Project	IEEE 802.16 Broadband Wireless Access Working Group < http://ieee802.org/16 >	
Title	Primitives in 802.16h – high level approach	
Date Submitted	2008-05-01	
Source(s)	Mariana Goldhamer Alvarion Ltd. 21A, Ha Barzel Street, Tel Aviv, Israel	E-mail: mariana.goldhamer@alvarion.com
Re:	LB 29	
Abstract	The document is a proposal for profiles based on the poll taken in November 2007 meeting, in relation with comment 092 in database IEEE 802.16/07-53r2	
Purpose	[Description of what <i>specific</i> action is requested of the 802.16 Working Group or subgroup.]	
Notice	<i>This document does not represent the agreed views of the IEEE 802.16 Working Group or any of its subgroups. It represents only the views of the participants listed in the “Source(s)” field above. It is offered as a basis for discussion. It is not binding on the contributor(s), who reserve(s) the right to add, amend or withdraw material contained herein.</i>

Primitives in 802.16h – high level approach

Figure 3—Illustration of the Network Control and Management System (Informational)

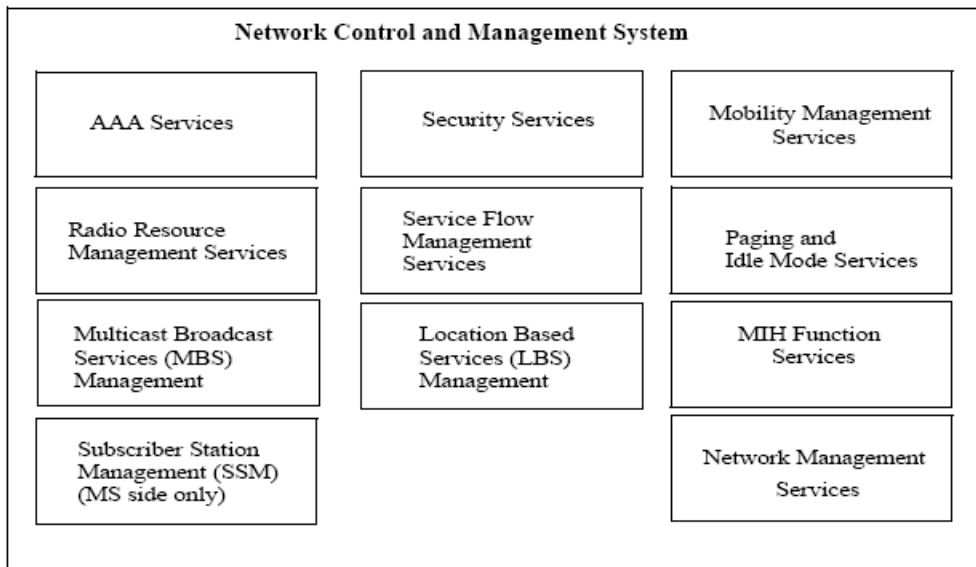
We will need to add a box named: Coexistence Services.

~~15.5~~ Add in Fig.3 a box named “Coexistence Services”
